FOOTHILLS WATER NETWORK

COMMENTS ON DRAFT ENVIRONMENTAL IMPACT STATEMENT (DEIS)

Yuba-Bear Hydroelectric Project (FERC #2266-102)
Licensee: Nevada Irrigation District

August 22, 2013

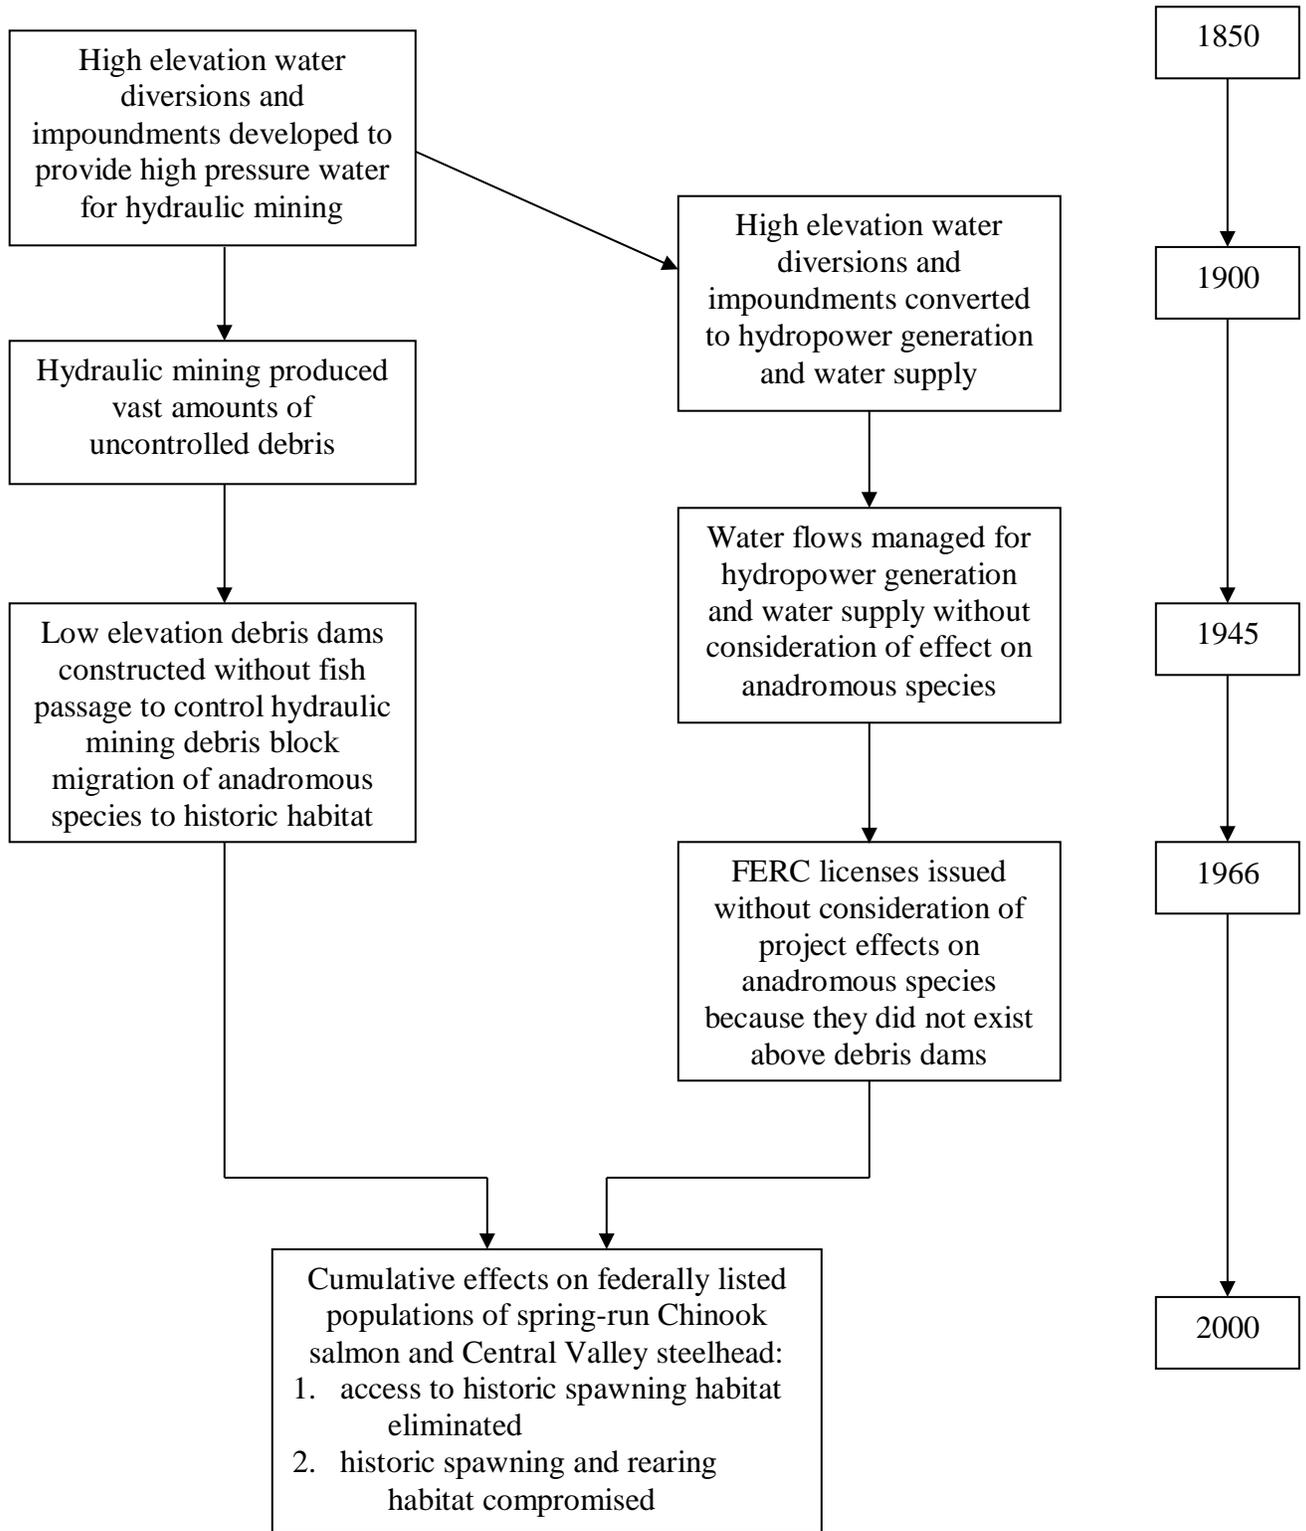
Taken together, the cumulative effects of past Project and other watershed activities, including mining, energy generation, debris management, water supply, and flood control within the Yuba River watershed as a whole and other project-affected streams resulted in and continue to result in or significantly contribute to:

In summary, FERC must provide a cumulative impacts analysis specific to the Yuba River watershed as a whole and other project affected streams that "...will identify other watershed activities including hydropower projects and will analyze the effects of the proposed project and alternatives in combination with other projects and activities" on Central Valley spring-run Chinook salmon and Central Valley steelhead. Results of the analysis may require development of mitigations that include the return of these species to their historic range and identifying actions necessary to mitigate cumulative effects on them.
